APPLICATION NO.	FILING DATE	FIRST NAMED INVENTOR	ATTORNEY DOCKET NO.	CONFIRMATION NO.
10/634,235	08/05/2003	Peter Bernhardt	1-24671	6403

Office Action Summary

DETAILED ACTION

DE-2,945,234

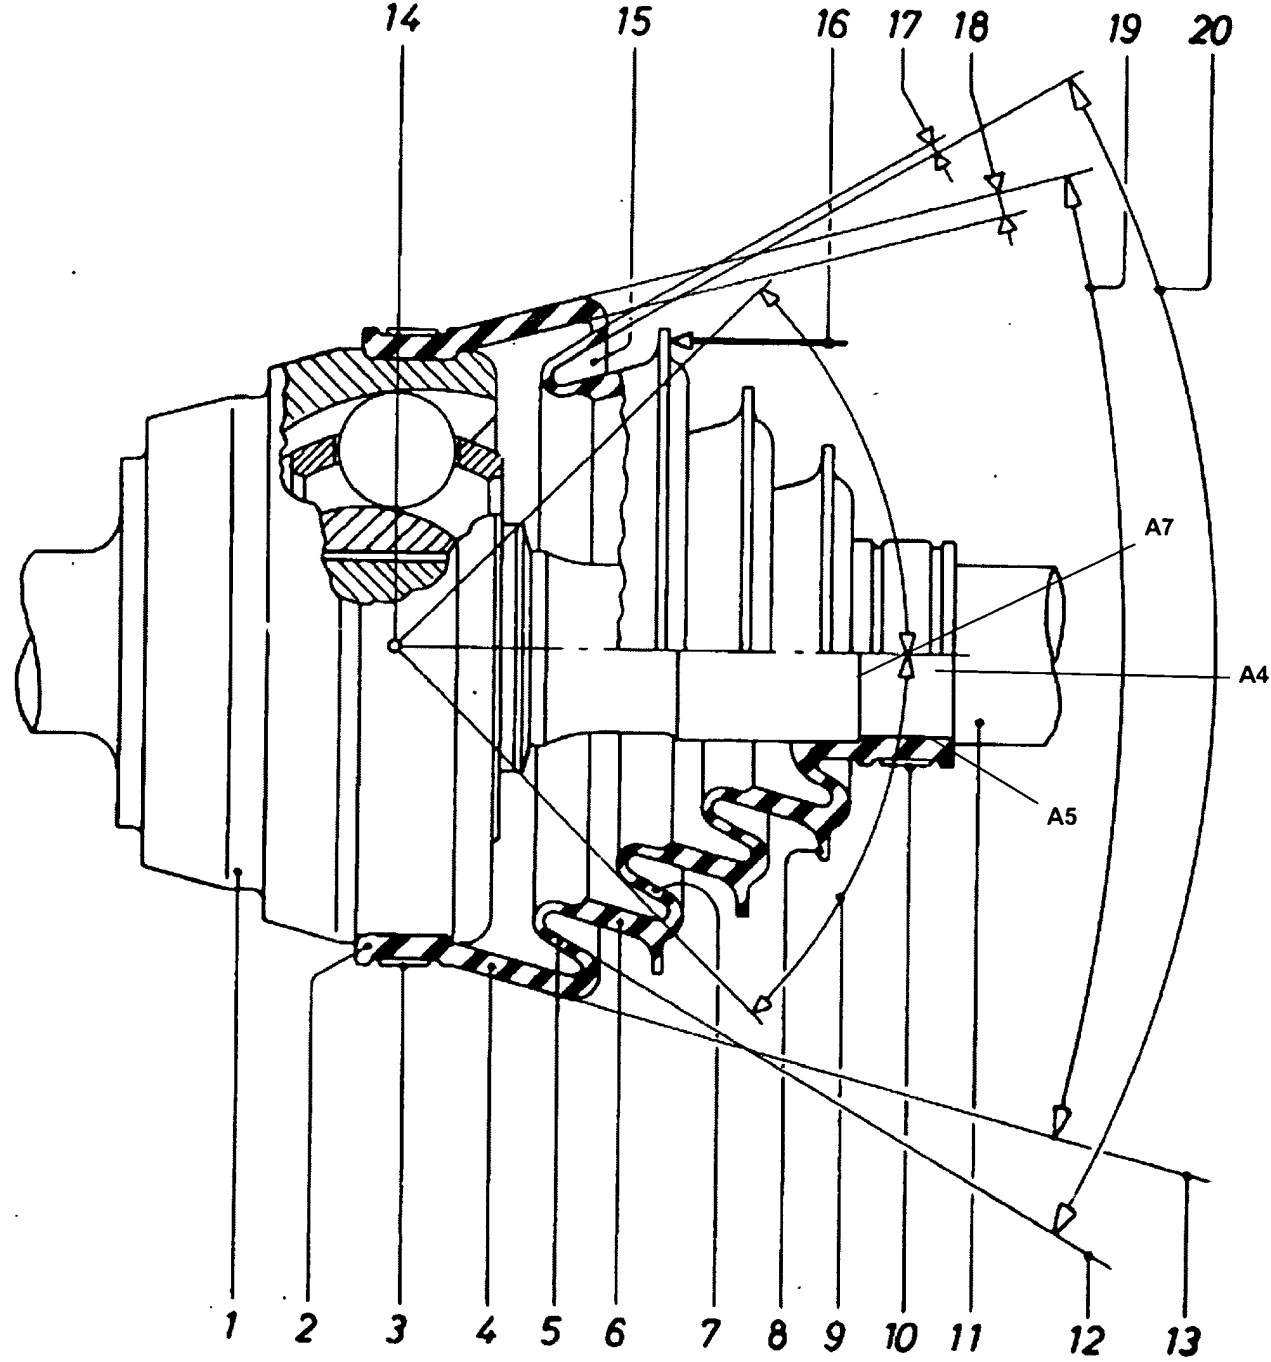
Claims 1-5 are rejected under 35 U.S.C. 102(b) as being anticipated by the German patent, DE-2,945,234 (see marked-up attachment).

Regarding claim 1, the German patent '234 discloses, in Figure 1, a ball joint comprising a housing **1**, a ball stud **11**, and a sealing bellows **2**. The sealing bellows **2** lies against the housing **1** and the ball stud **11**. The ball stud **11** has a holding surface **A4**. A sealing surface **A5** of the sealing bellows **2** lies against the holding surface **A4**. The sealing surface **A5** is longer than the holding surface **A4** along a longitudinal axis of the ball stud **11**.

Regarding claim 2, the holding surface **A4** and the sealing surface **A5** are cylindrical.

Regarding claim 3, contact surface **A7** is provided on the ball stud **11** and adjoins the holding surface **A4** on a side facing away from the housing **1**. Applicant is reminded that the recitation that an element is "adapted to" perform a function is not a positive limitation but only requires the ability to so perform. It does not constitute a limitation in any patentable sense. *In re Hutchison*, 69 USPQ 138. Therefore, the ball stud **11** can be adapted to be mounted to a component.

Regarding claim 4, the sealing bellows **2** is provided with a metal ring **10** urging the sealing surface **A5** against the holding surface **A4**.

Regarding claim 5, the sealing bellows **2** is dimensioned such that the sealing bellows **2** cannot slip off from the holding surface **A4**.
